CITY OF CONWAY, ARKANSAS HISTORIC DISTRICT COMMISSION

November 23, 2020 · 5:30pm · City Hall · 1111 Main Street

Ingram Hartje House - Exterior Modifications

New Single-Family Residence

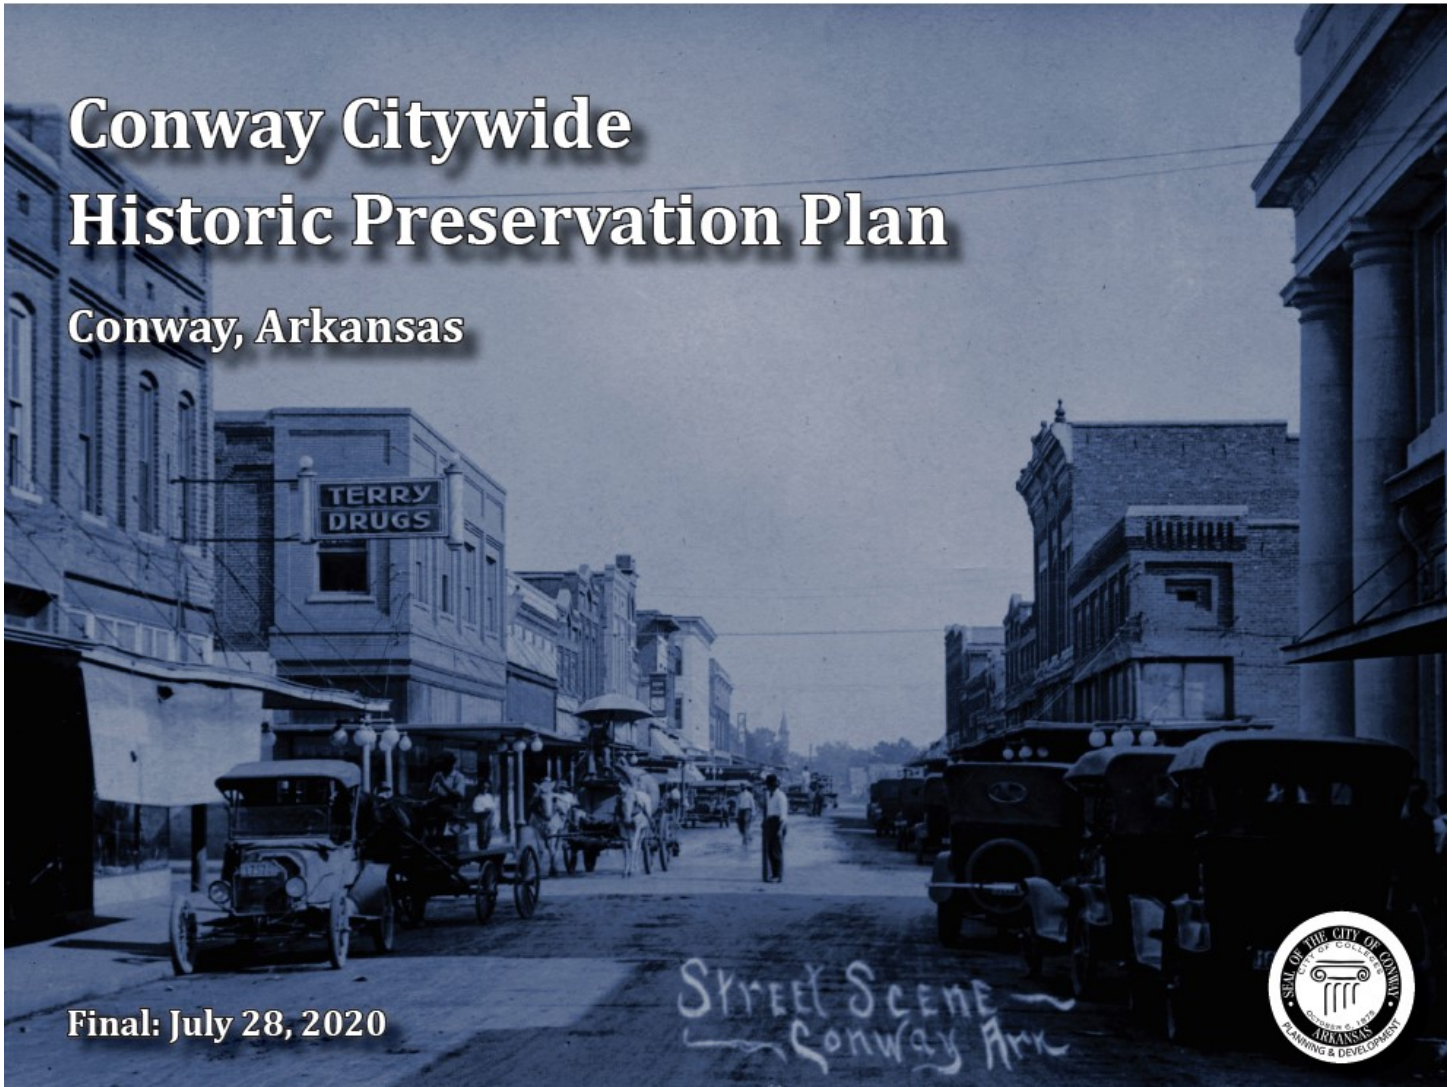
The area is very commercial in character with wall signage and pole signs being commonplace. With that, most signs in the area appear larger or comparable in size. A larger and taller sign is warranted for this location given its location on a commercial corridor.

1. Canopy trees shall be planted at a ratio of one tree every 30 feet along Sixth Street in accordance with the site's approved development review plan with the City.
